## **Additional Comments Regarding AES Puerto Rico Ash Cell Construction and Groundwater Monitoring**

**Dr. Ranajit (Ron) Sahu**

**Figure 8:** Eh-pH diagrams for selenium under geochemical conditions specific to (A) MW-3, (B) TW-102, and (C) TW-103.

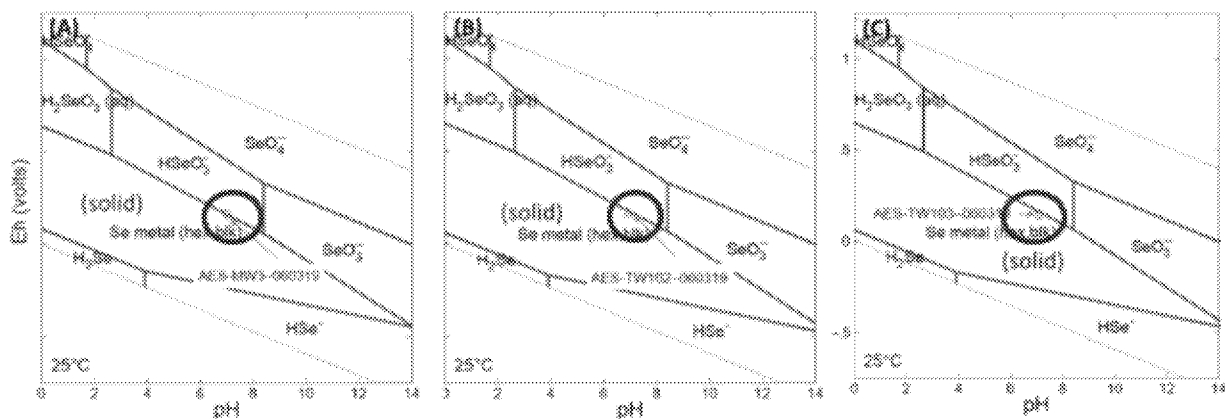
For selenium, Haley and Aldrich provide the following pH-Eh diagrams for three well data, MW3, TW102, and TW103. The red circles are my highlights.

It is clear that in each instance the data are at the very boundary between the solid and dissolved phases at each well. At the very least, this is not a robust finding that selenium will be present in the precipitated solid phase, indicating MNA for this metal. I note the very qualified, speculative, and hedged language used by Haley and Aldrich based in their own analysis:

**Figure 9:** Eh-pH diagrams for molybdenum under geochemical conditions specific to (A) TW-102, (B) TW-103, (C) MW-3, and (D) MW-4.

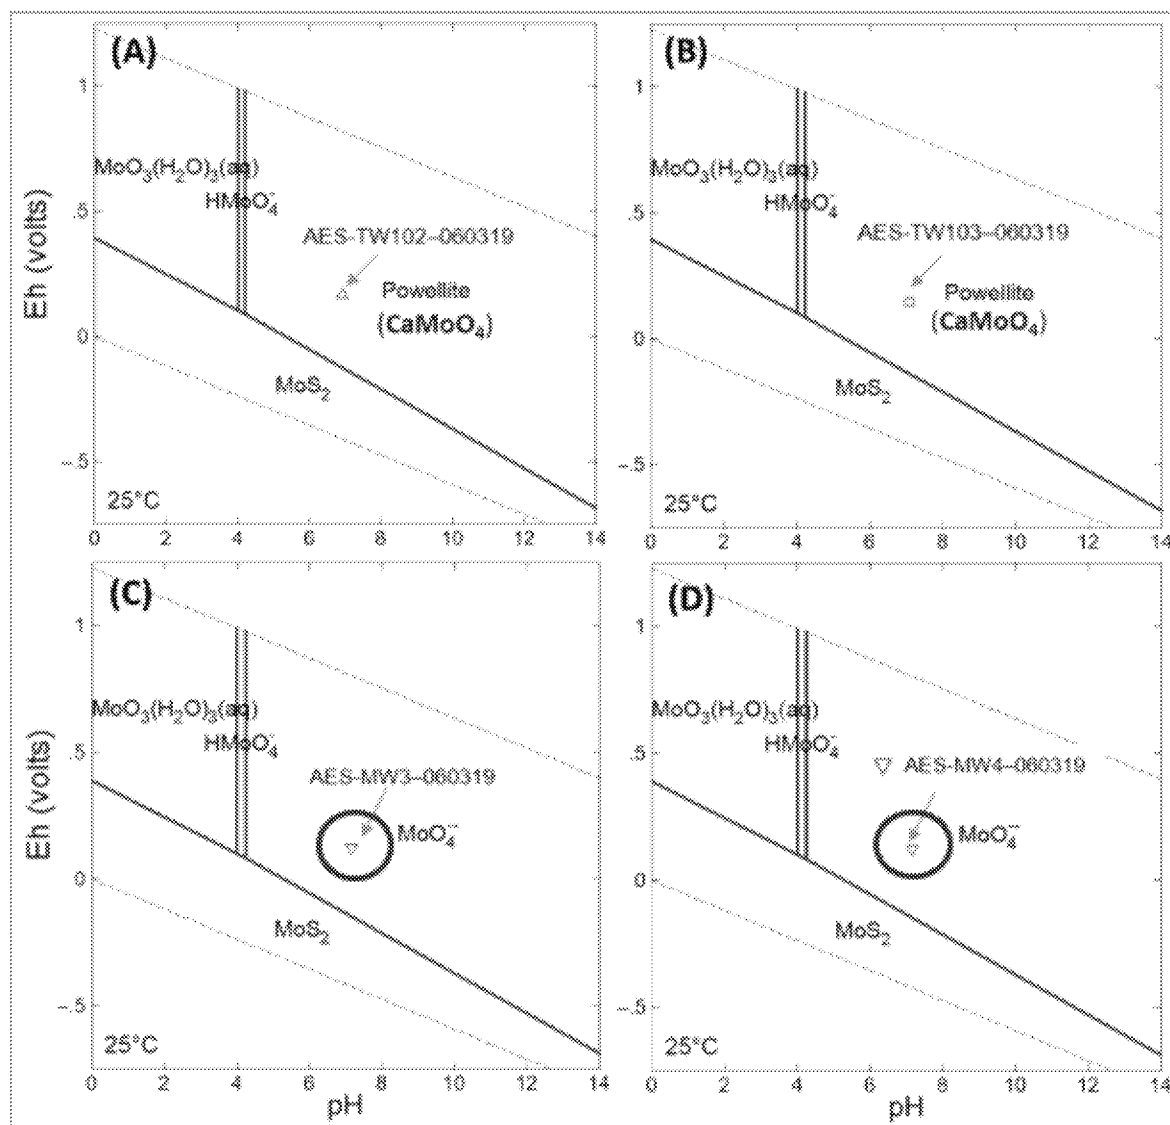
It is obvious that there is no precipitation of molybdenum at least at MW-3 and MW-4. In fact, Haley and Aldrich confirm: “For MW-3 and MW-4, no powellite precipitation occurs and the aqueous species – molybdate ( $\text{MoO}_4^{2-}$ ) is the predicted outcome.” (Emphasis added.) Thus, there is simply no basis to presume MNA for molybdenum, regardless of future speculation as noted by Haley and Aldrich’s analysis: “Other attenuation mechanisms, such as adsorption and matrix diffusion, likely play a synergistic role in observed Mo attenuation at the Site.”
